**NOTICE OF DECISION TO CONSENT TO CHANGE TO PROPOSAL DURING  
ASSESSMENT**

Mardie Project  
Assessment No. 2167

**STATEMENT OF REASONS**

**Proposal:** Mardie Project (Assessment Number 2167)

Figure 4 – Changes to impacts on BCH (Intertidal)

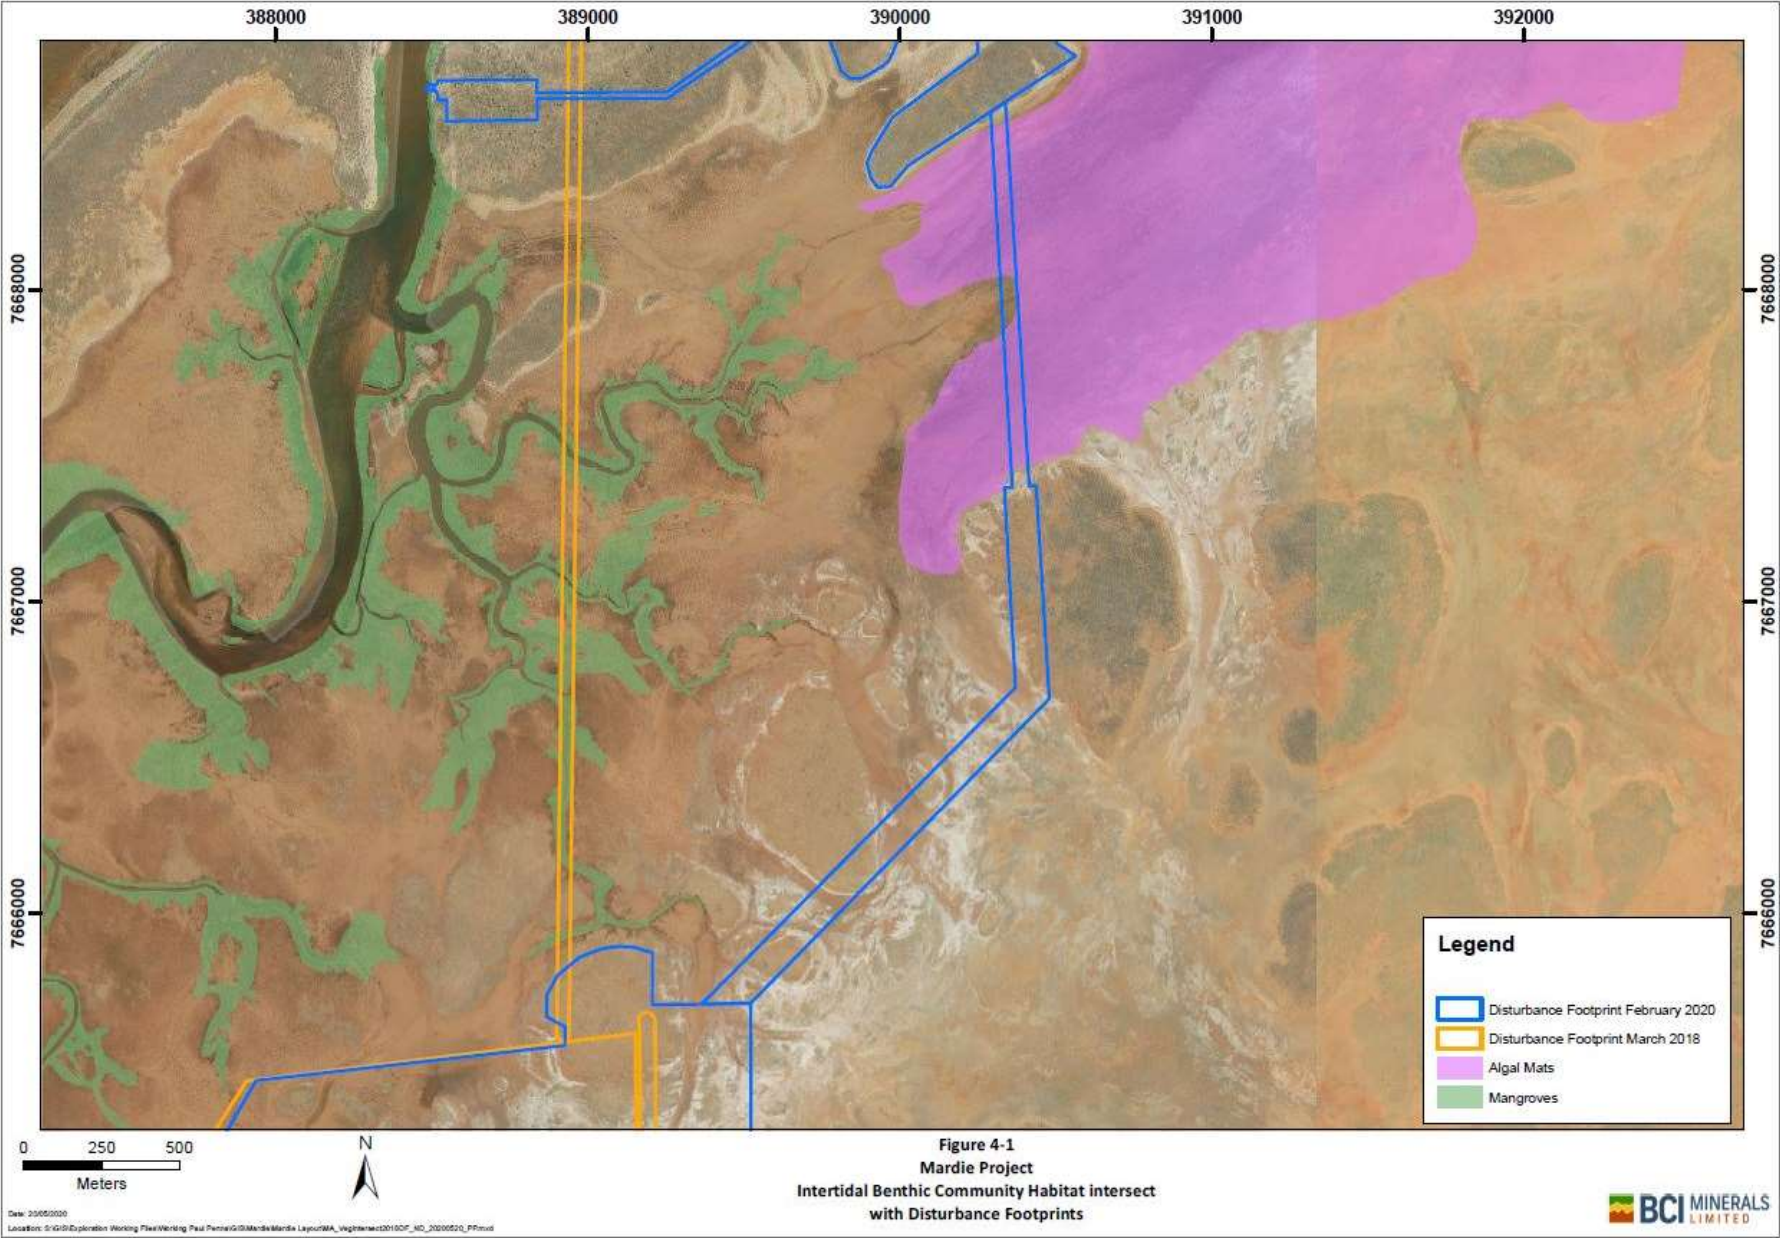
- An increase in direct impacts to intertidal BCH from 11 ha to 16.5 ha (59%). This quantification is based on the assumption that a construction/maintenance track was included with the trestle jetty for the original proposal.
- A change to the composition of benthic habitat directly impacted by the crossing structure. While direct impacts to different BCH types have not been quantified by the proponent, Figure 4 indicates that the re-alignment would result in a positive change, reducing the direct impacts to mangrove communities.
- An increase in indirect impacts to BCH (mostly algal mat) due to ponding or diversion of tidal flows caused by the rock causeway. The proponent has provided modelling (Figure 5) which demonstrates that the causeway would result in minimal changes to tidal flows, compared to a base case of no development.

- 59% (5.5 ha) increase in direct impact associated with the change is considered to be relatively low,
- the change to indirect impacts has been demonstrated to be minimal, and
- the re-alignment of the crossing would result in a decreased impact to significant mangrove populations.

Figure 5 – Intertidal modelling (Causeway)

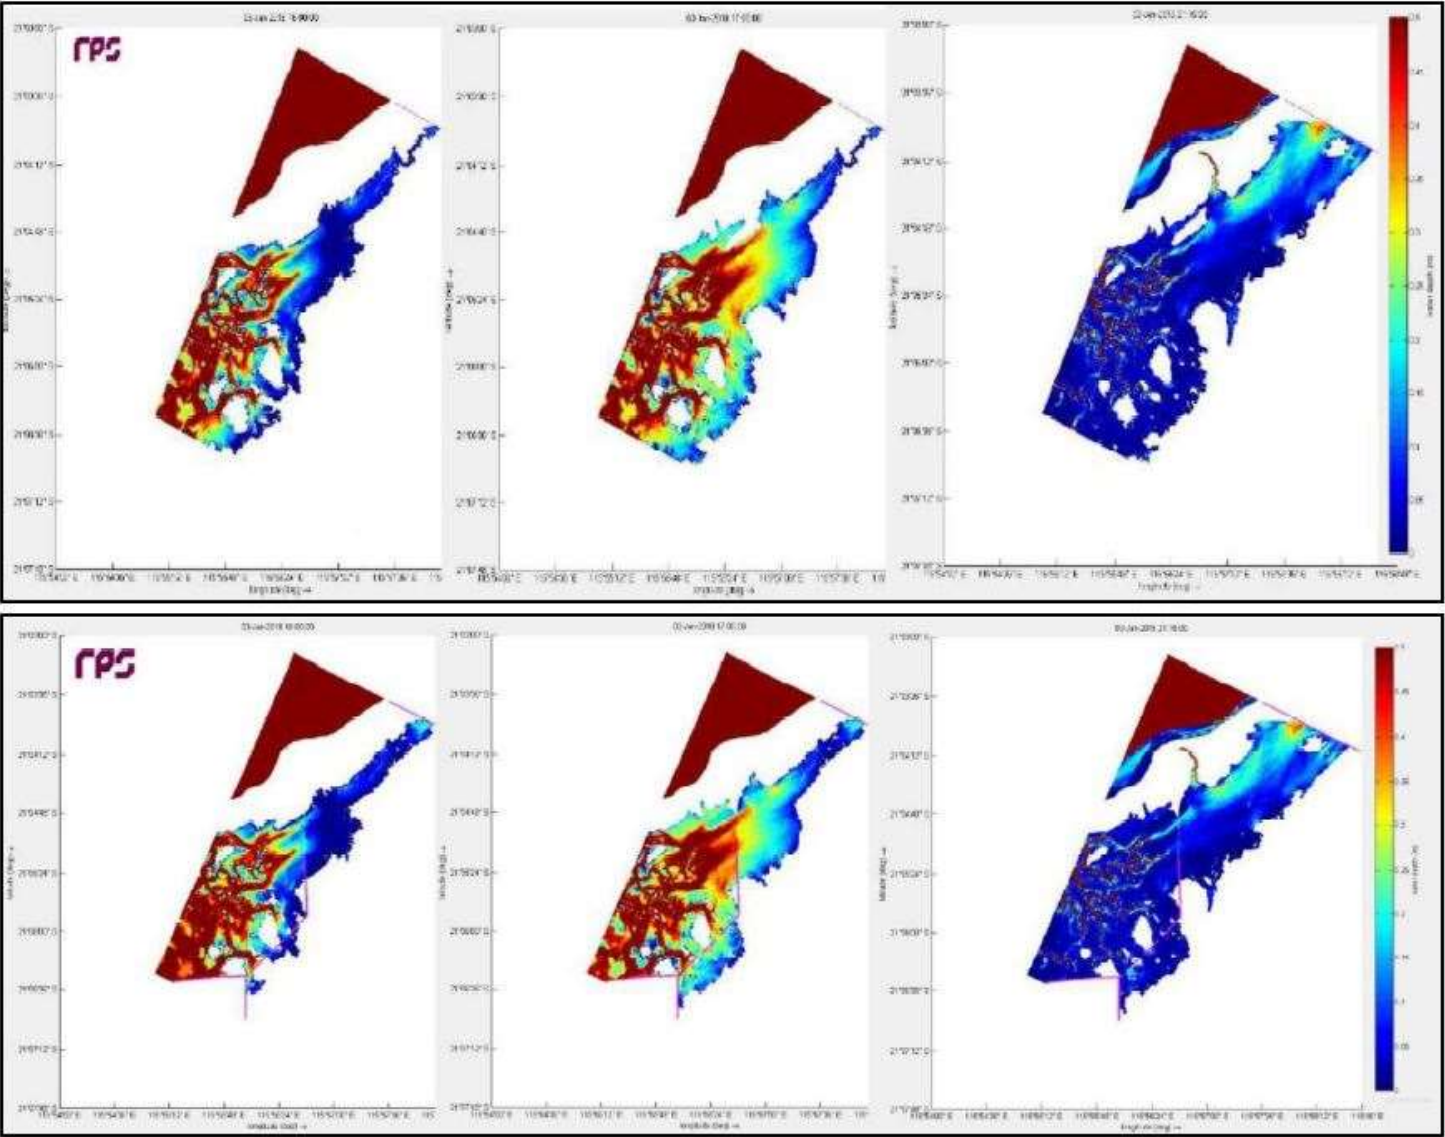
- e) The increase of 5.5 ha direct impacts to BCH associated with changing the intertidal crossing infrastructure is not considered to be significant.
- f) Modelling has demonstrated that the change to indirect impacts associated with the rock causeway would be minimal.
- g) Changes to the development envelope, including re-alignment of the intertidal crossing and dredge envelopes and exclusion of significant species and sites including Mardie Pool, are likely to result in a reduction in impacts to relevant environmental values.

Figure 1 – Changes to Development Envelopes

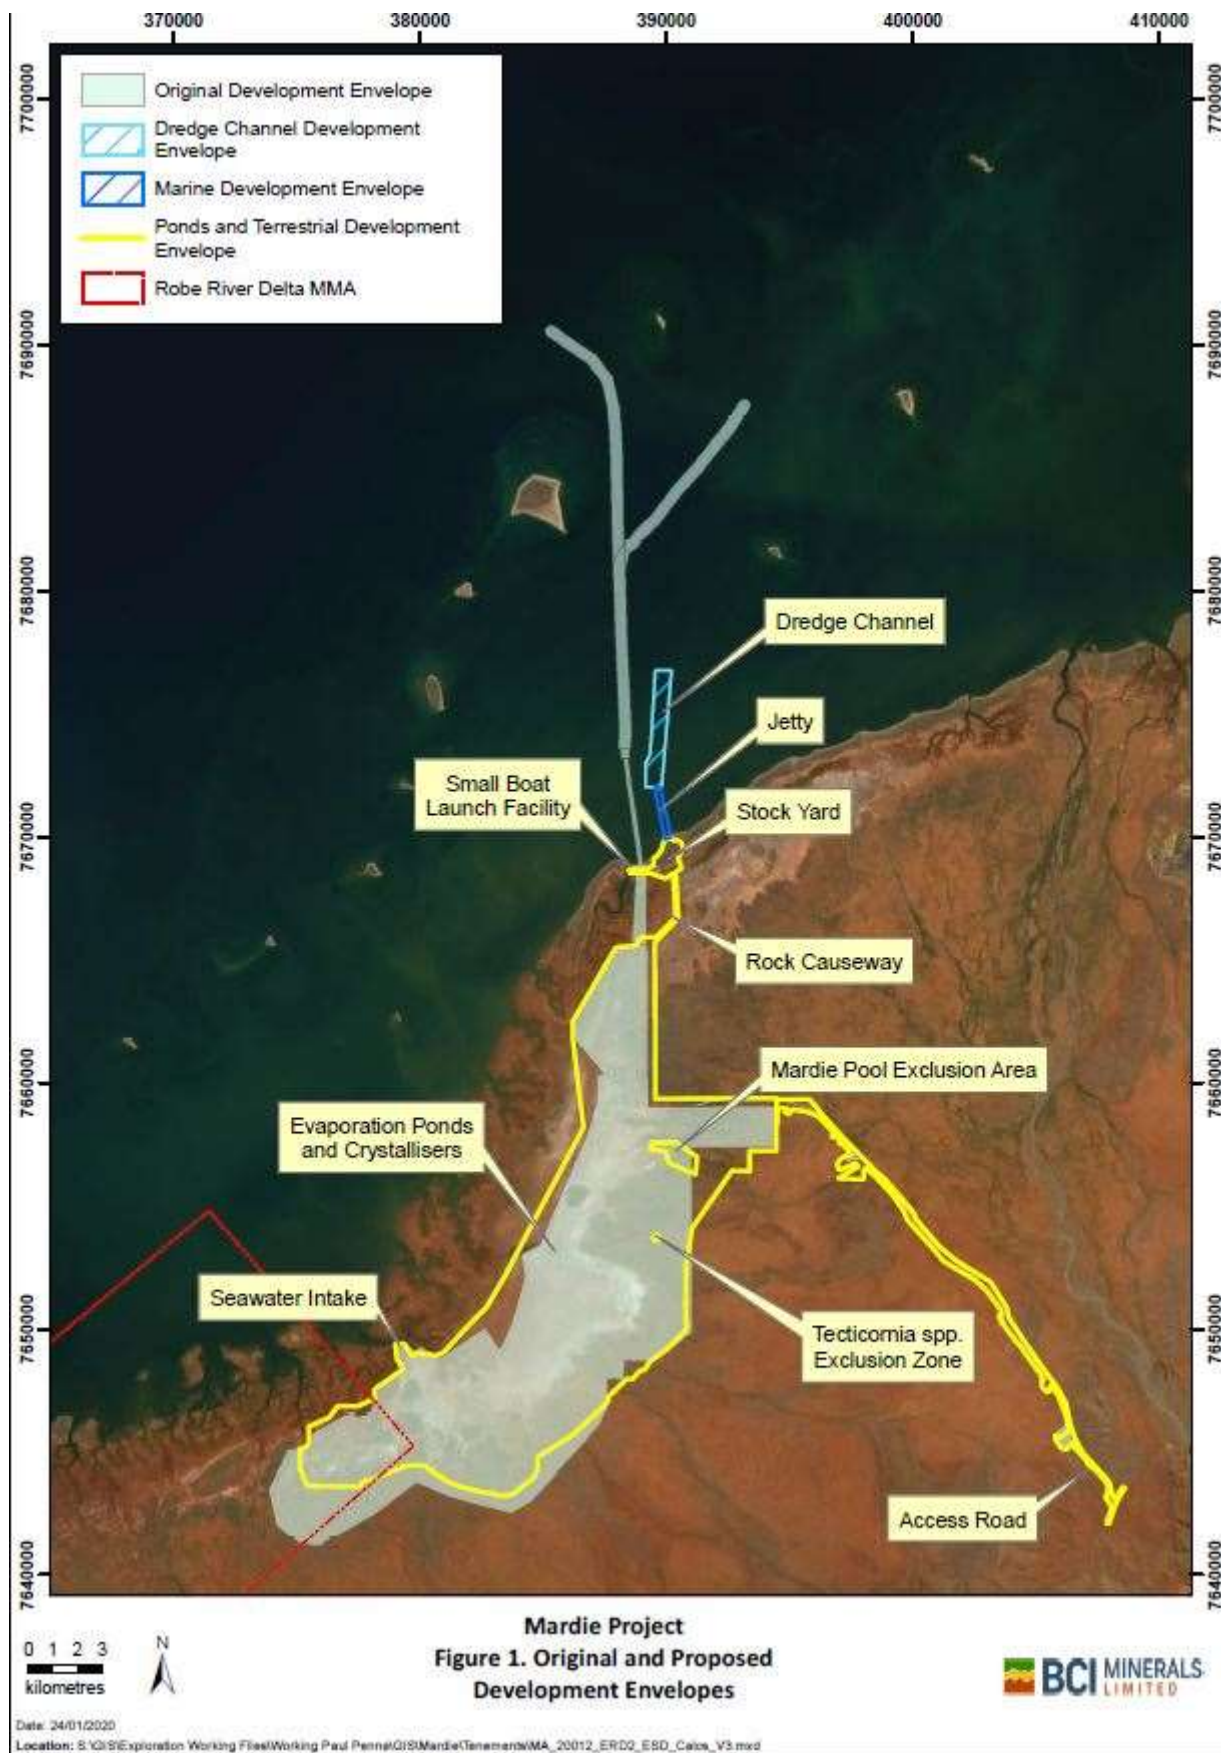
<b>Element</b>	<b>Current Proposal</b>	<b>Changed Proposal</b>
Development envelopes	<ul style="list-style-type: none"> <li>• 16,937 ha</li> <li>• As shown in Figure 1</li> </ul>	<ul style="list-style-type: none"> <li>• 16,024 ha</li> <li>• As shown in Figure 1</li> </ul>
Disturbance Footprint	<ul style="list-style-type: none"> <li>• 9,551 ha</li> <li>• As shown in Figure 2</li> </ul>	<ul style="list-style-type: none"> <li>• 11,221 ha</li> <li>• As shown in Figure 2</li> </ul>
Marine Infrastructure Disturbance	<ul style="list-style-type: none"> <li>• 22 ha</li> </ul>	<ul style="list-style-type: none"> <li>• 7 ha</li> </ul>
Dredging program	<ul style="list-style-type: none"> <li>• 146 ha direct disturbance</li> <li>• 500,000 m<sup>3</sup> dredge volume</li> </ul>	<ul style="list-style-type: none"> <li>• 55 ha direct disturbance</li> <li>• 800,000 m<sup>3</sup> dredge volume</li> </ul>
Intertidal crossing	<ul style="list-style-type: none"> <li>• Trestle jetty</li> <li>• As shown in Figure 2</li> </ul>	<ul style="list-style-type: none"> <li>• Rock Causeway</li> <li>• As shown in Figure 2</li> </ul>
